Appl. No.: 10/707,556
Amdt. Dated: 10/16/2005
Reply to Office action of: 09/22/2005

REMARKS/ARGUMENTS

FIG. 16

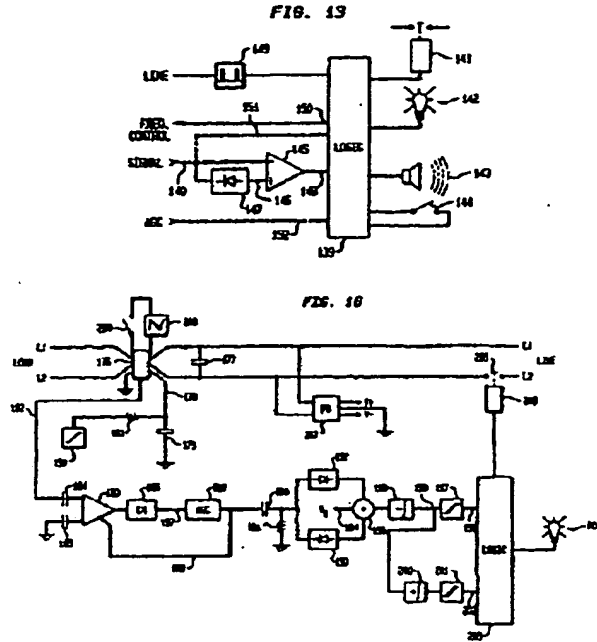
With regard to Claim 2, Blades, in figure 16, teaches a step wherein the current acquisition (176) is carried out independently for the load connected to the electrical assembly prior to the load.

not solely indicative of an unwanted arcing thus sampling of a very large number of
samples is required to provide a satisfactory level of no false positives (see for example,
Col. 9, line 52 – Col. 10, line 18). To process this large number of samples quickly
enough the preferred analyzer back-end of the Blades reference does not use a
microprocessor (see for example, Col. 24, lines 56 – 60, Col. 26, lines 21 – 34, Figs. 13 &
